ALAMEDA DRIVE - AMENDMENT SUMMARY

KEY CHARACTERISTICS - AMENDMENT

DAWSON PROMENADE - AMENDMENT SUMMARY

1 PROPOSED 70' ROW

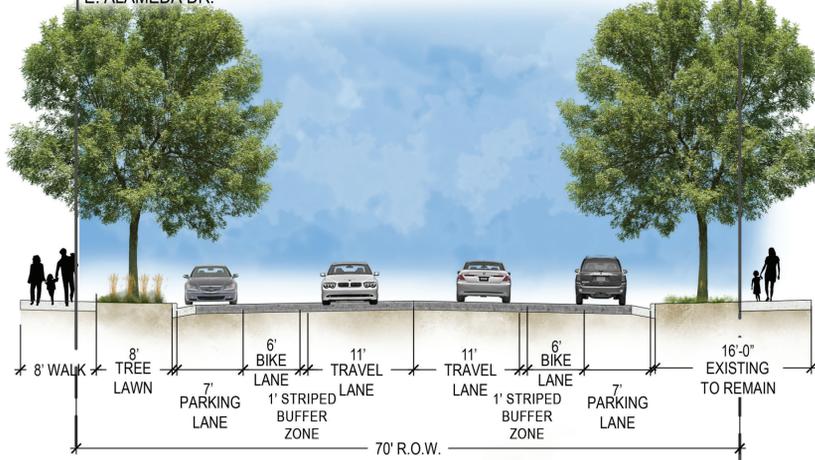
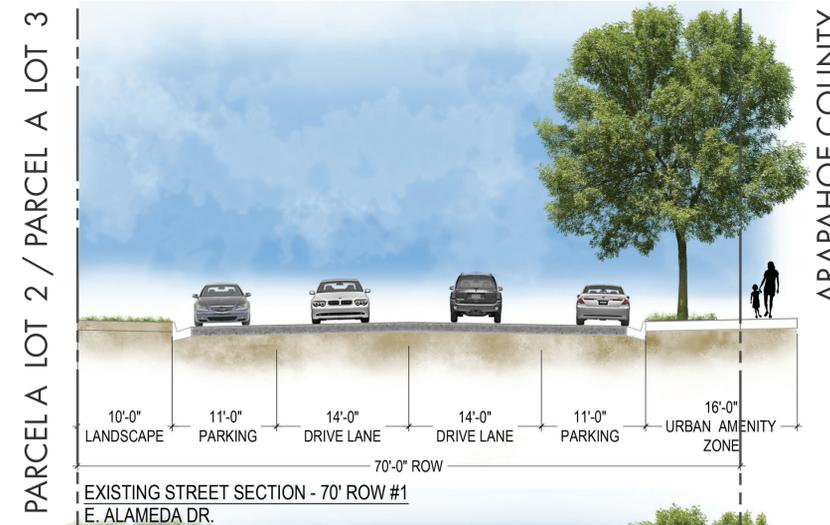
1. E. Alameda Dr. Characterized as **Primary Street** within Metro Center
2. Existing tree canopy and streetscape on east side will be preserved
3. 8' min sidewalk width

4. Limited Curb Cuts
5. On Street Parking
6. Urban Amenity Zone (between back of curb and ROW, on the west side **and shall include the additional ~ 8' of public realm as shown in the street section**) All furnishings to be Tier 2. See Section 3.4. Minimum 6' through way must be maintained.

11. In PA-A2, 80% of the **Alameda Dr.** property line will consist of the primary building envelope(s), of which 80% of the primary building envelope(s) will consist of storefronts/building transparency setback no further than the western edge of the Alameda Drive Urban Amenity Zone. Applies to the western side of Alameda Dr. only.

12. In PA-A2 a minimum of 80% of the frontage of developable land area along **Alameda Drive** that is not allocated for storm water drainage/ water quality facilities in Planning Area A-2 will consist of building frontage storefronts/ building transparency. Building location will be no further back than the maximum front setback of 10 feet." This percentage will be provided where functionally appropriate, i.e. exclusive of Fire rooms, ingress/egress, etc. essential to meet building code requirements. **The setback location along Alameda Dr. shall start at the edge of the additional public realm shown in section 3.2.7. Note there may be a need for setback exceptions where there are additional main street enhancements along Alameda Dr. These exceptions will be determined at time of site plan.**

13. Building frontages shall "wrap the corners" of PA-A2 either through architecture or as an extension of the public realm from the building façade to the street, no less than 60' from the corner of the building.

PROPOSED PLAN VIEW - 66' TRACT
DAWSON PEDESTRIAN PROMENADE

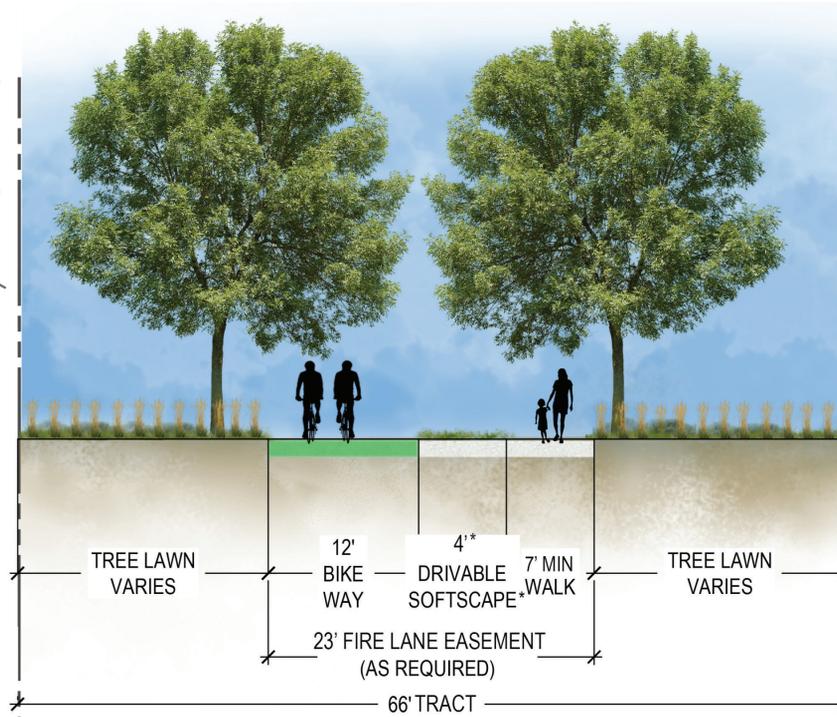
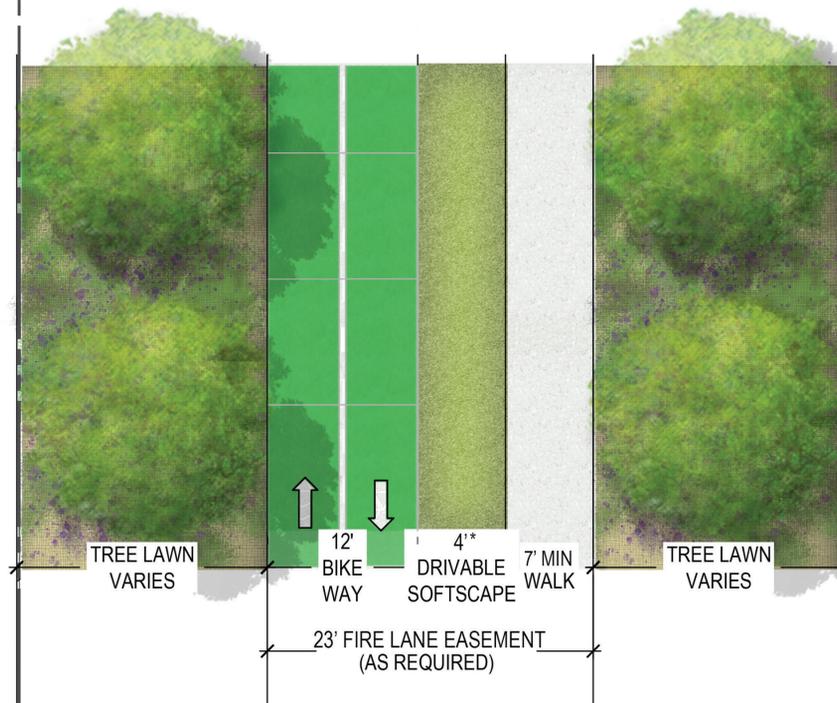
1. Proposed Conceptual Amenities

- Multi-Modal Pedestrian Transportation with **Designated, Painted Bike Lane**
- Enhanced Hardscape to include **drivable softscape where applicable for fire access.**
- Enhanced Site Furnishings
- Enhanced Pedestrian Lighting
- Bike Racks, **Repair Stations**, and Pet Pickup Stations
- Streetscape Character shall be designed to create unique sense of place and tie into adjacent plaza and park spaces for a cohesive connection between the thoroughfare and larger gathering areas.
- **Festival Street**
- **Public Art**
- **Varied Seating Options**
- Trees: Deciduous shade trees 30-40' o.c. min. planted in 5' x 15' minimum planting zones
- Landscape: Urban landscape that meets or exceeds the City's urban streetscape standards
- Tier 2 pedestrian lighting

Dawson Pedestrian Promenade is 66 feet wide to allow for flexibility of future development opportunities.

*DRIVABLE SOFTSCAPE REFERS TO GRASSPAVE OR SIMILAR PRODUCT SO LONG AS IT MEETS APPLICABLE REQUIREMENTS FOR FIRE APPARATUS AS DEFINED IN THE CITY OF AURORA'S ROADWAY DESIGN AND CONSTRUCTION SPECIFICATIONS MANUAL. TO BE APPROVED AT TIME OF SITE PLAN.

PROPOSED LANDSCAPE BUFFER ENHANCEMENTS ALONG BUFFER BETWEEN GREENWAY PARK AND PARCEL PA-A1.

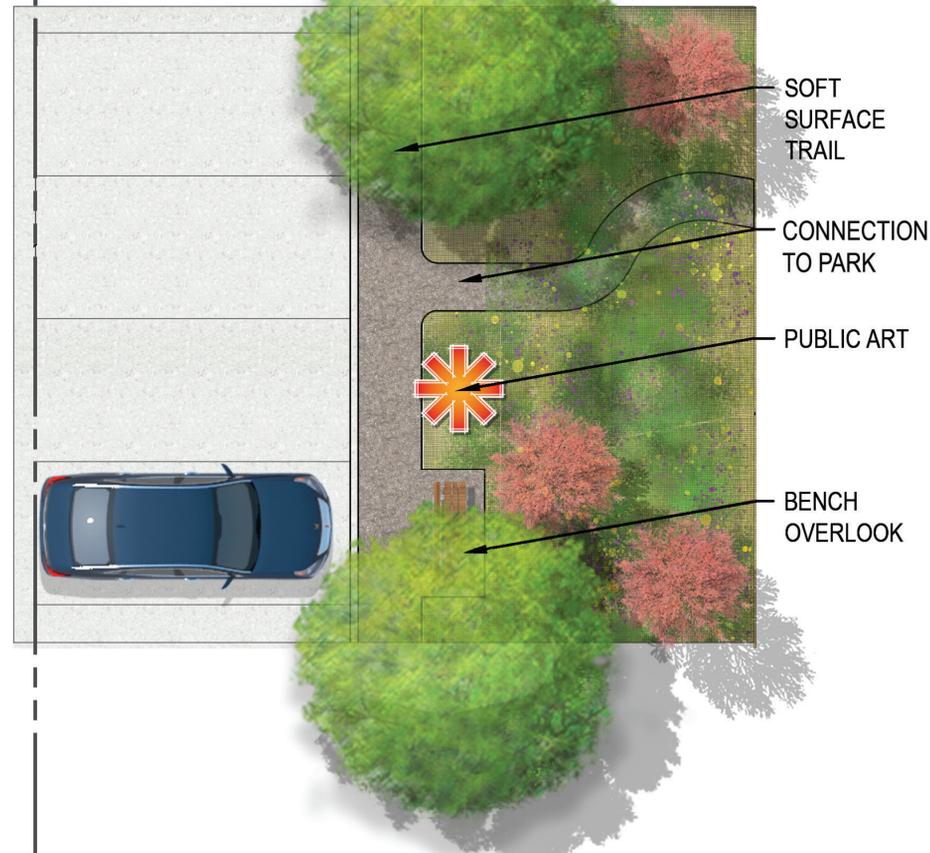
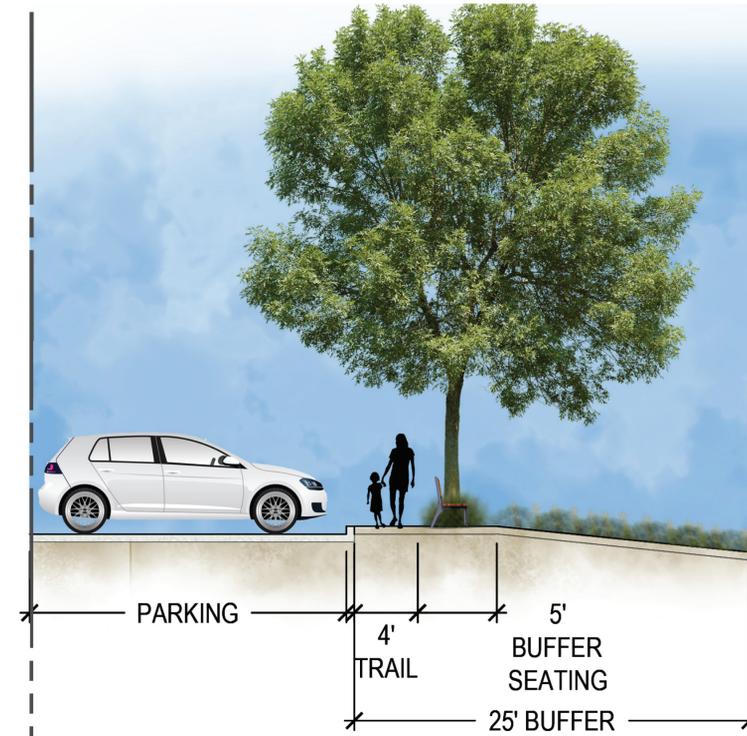
- Maintain 25' required buffer width
- Increase plant requirements by 20%
- Provide 4' soft surface trail within buffer
- Provide breaks in buffer with seating to connect to the park space visually and physically where appropriate
